Schenectady County
Purchasing Department
ADDENDUM

RFB-2021-15
Elston Hall Facade
ADDENDUM #4

July 9, 2021

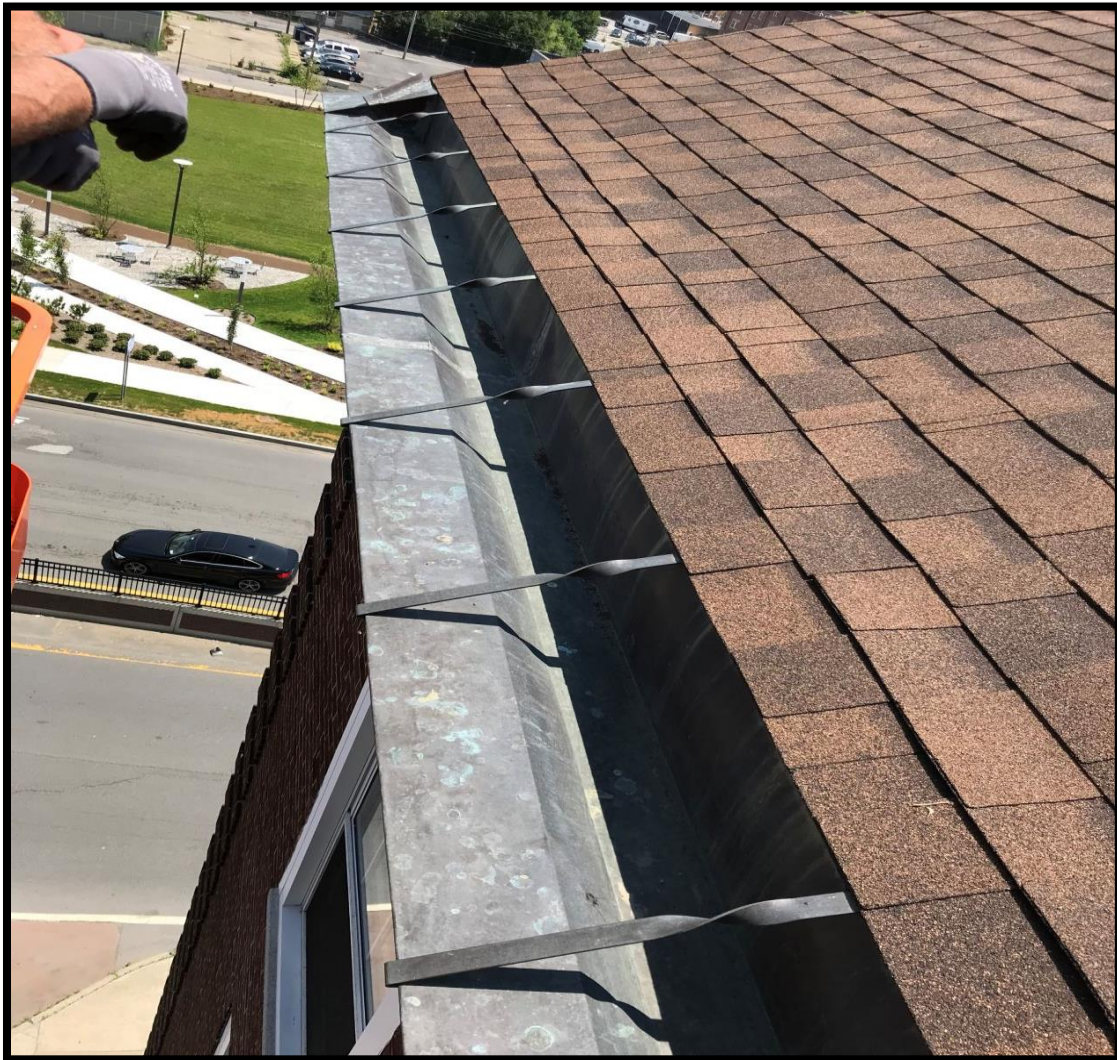
- I wanted to ask if there was any information on the roof structure and if it is capable of being loaded for swing stage access? If so, myself and a couple of my colleagues would plan to set up a time with the college to gain access to the roof to get a better look.

Response: There are no available drawings of the roof structure. The interior is finished and observations cannot be made. We do not believe that swing staging can be used due to the interior gutter and sloped roof. These are photographs showing the roof edge conditions:
